Access Compliance Report Public Rights-of-Way (Curb Ramps)

Main Street: WELDON_HEIGHTS		Cross Street: HEARTHSIDE_RD		Location:	NE
ADA ID: RPAT211104140746	Ramp Type: Type 4 - Parallel	Initial Pass/Fail: Fail	Overall Compliance: No	Severity Score:	32
Codes/Mitigation Info/Possible Solution			Field Measurements/Component Compliance

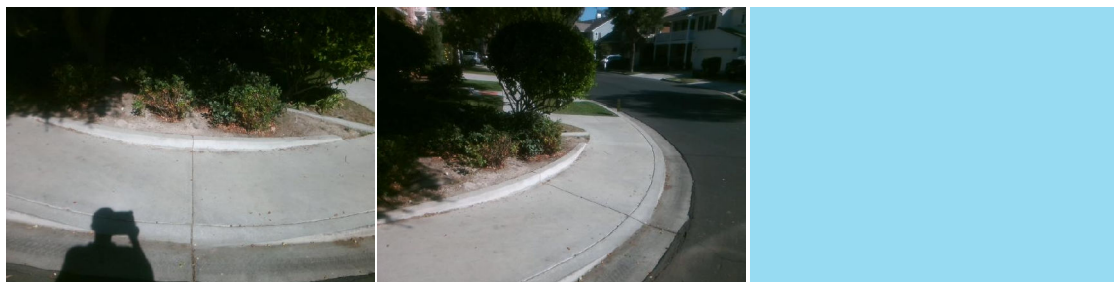
Compliance	Description	Data	Compliance	Description	Data
N/A	Ramp Length LT (in)	86	N/A	Ramp Length RT (in)	80
Yes	Ramp Width LT (in)	53	Yes	Ramp Width RT (in)	53
No	Ramp Run Slope LT (%)	12.1	Yes	Ramp Run Slope RT (%)	1.1
No	Ramp Cross Slope LT (%)	4.2	No	Ramp Cross Slope RT (%)	3.5
N/A	Landing Present	N/A	N/A	DWS Provided	N/A
N/A	Landing Length (in)	N/A	N/A	DWS Contrast	N/A
N/A	Landing Width (in)	N/A	N/A	DWS Length (in)	N/A
N/A	Landing Run Slope (%)	N/A	N/A	DWS Full Width	N/A
N/A	Landing Cross Slope (%)	N/A		DWS Offset Type	N/A
N/A	Landing Movement Obstructed?	N/A	N/A	DWS Offset Left (in)	N/A
	Landing Movement Type	N/A	N/A	DWS Offset Right (in)	N/A
N/A	Landing Shared	N/A			
N/A	Clear Space	Yes			
N/A	Clear Space To Crosswalk (in)	N/A			
N/A	Marked Crosswalk 1	No	N/A	Marked Crosswalk 2	No
	Crossing 1 Direction	NW		Crossing 2 Direction	SW
	Marked Crosswalk 1 Width (in)	N/A		Marked Crosswalk 2 Width (in)	N/A

Remove & Replace Curb Ramp With Two New Directional Ramps or Equivalent.
